ENGINEERING ASSESSMENT

File: DA 191/2023

Date: 27 March 2024

Re: CONSTRUCTION OF A NEW ADMINISTRATION AND AMENITIES BUILDING – LOT 162 DP 751709
– 9 MURPHY ROAD, HANWOOD

Figure 4: Central Accessway

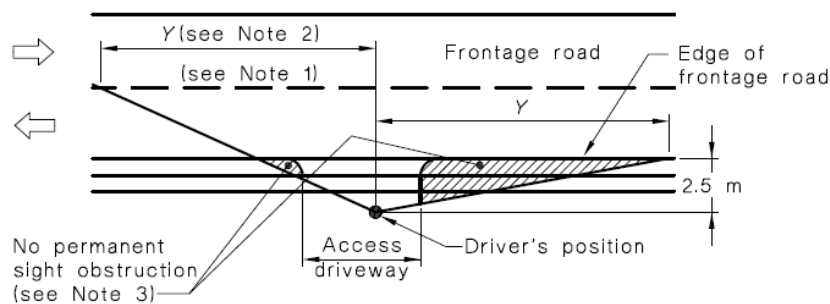
The central accessway is located between the eastern most and western most accessways and is approximately 280m east of Kidman Way. The accessway is approximately 5m wide with access tapers to Murphy Road, it is bitumen sealed and provides access to two residential dwellings on the site as well as the processing plant. As part of the development the managers residence to the west of the existing central accessway will be demolished to enable the construction of the new staff amenities and administration building. The proposed development will also obstruct access to the processing plant from this accessway. The Traffic Impact Assessment prepared by PSA Consulting indicate that visitors and staff drop off will be to the south of the proposed staff administration and amenities building and will occur via the central accessway. As a result, it will be conditioned that the accessway be upgraded as part of this development.

As a minimum the proposed central accessway is to be constructed of bitumen in accordance with Council's *Engineering Guidelines - Subdivision and Development Standards*. Design drawings for the accessway must include designs and specifications for all proposed works and must be submitted to Council for approval **prior to the issue of a Construction Certificate**.

The turning path diagrams prepared by the applicant's consultant, PSA Consulting, submitted with the traffic impact assessment, show that simultaneous two-way movement of two passenger vehicles through the proposed central accessway can be achieved. As such, it will be conditioned that the largest vehicle to access the proposed staff administration and amenities building through the central accessway will be light passenger vehicles.
